Product Change Notice (PCN)

Subject: RZ/V2N Product Mask Version Change

Publication Date: 6/25/2025

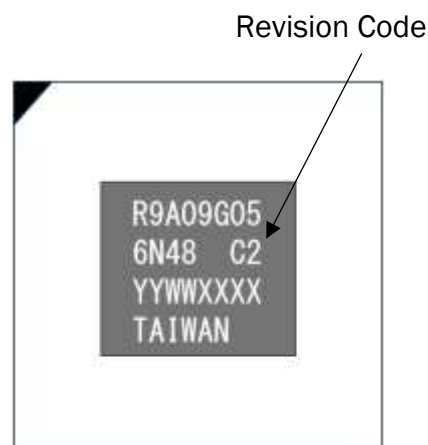
Revised products can be identified by the revision code 'C2' marked on the package or by reading the value from the LSI Device ID register. Additionally, for the revised products, the last digit of the booking part number will be changed from 0 to 1.
